Re: Response to Request for Additional Information

This letter provides the information requested by your letter dated January 31, 2011, "Rensselaer Polytechnic Institute, Request for Additional Information Regarding the Renewal of Facility Operating License No. CX-22 (TAC No. 1591)

Response to Detailed Questions

TECHNICAL SPECIFICATIONS

Figure 1: RCF Management Organization

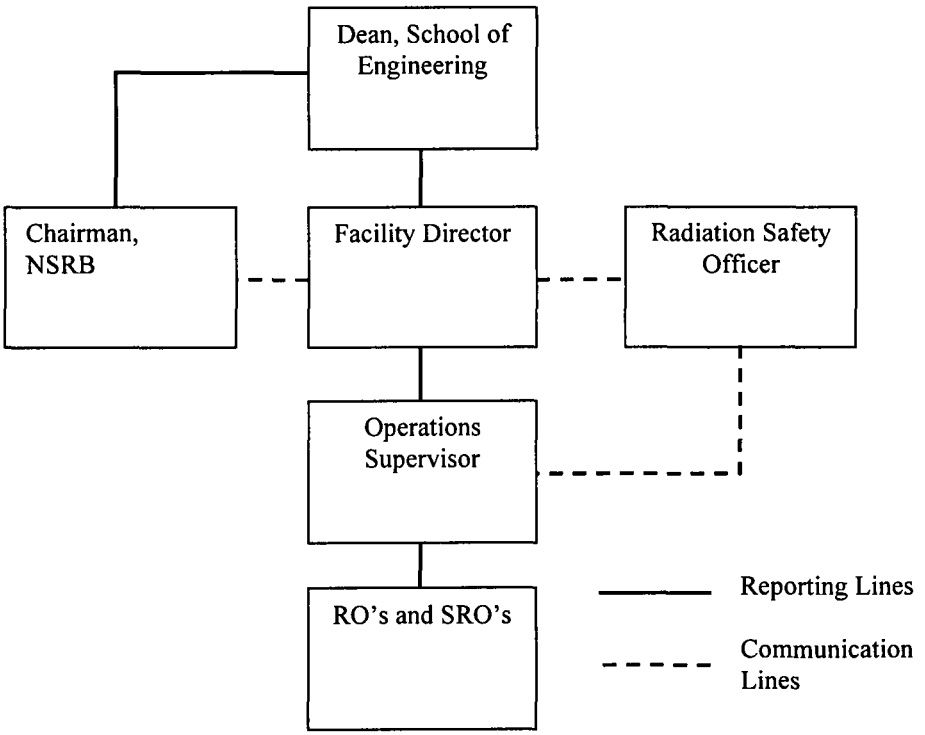
11. TS 6.1 specifies the minimum qualification for the Facility Director as an advanced degree in nuclear science or nuclear engineering. This is inconsistent with ANSI/ANS-15.4, Section 4.3 which recommends at least six years of nuclear experience with only four of those years being fulfilled by time spent in study. Explain the reason for not requiring the Facility Director to have any related experience other than time spent in study.

12. Secction 6.2.2(2) of ANSI/ANS-15.1 recommends that, "the operating staff (i.e., the Level 2 facility director or administrator and anyone who reports to that person)," should not constitute the majority of a quorum. TS 6.2, specifies that the majority of a quorum shall not be composed of operating staff (administrative levels 3 and 4). Provide a justification for not including the Facility Director in the operating staff as it applies to quorums, or revise the proposed TS as appropriate.

Paragraph 3 in T.S. 6.1 Selection and Training changed to comply with ANS./ANS 15.4-2007, and now reads, "Level 1 and 2 personnel are not required to have operating licenses and will be appointed by the appropriate bodies at RPI. The Facility Director shall have a minimum of six years of nuclear experience. The individual shall have a recognized baccalaureate or higher degree in an engineering or scientific field. The degree may fulfill up to four of the six years of nuclear experienced required.

"Administrative levels 3 and 4" changed to "i.e., the Level 2 facility director or administrator and anyone who reports to that person".
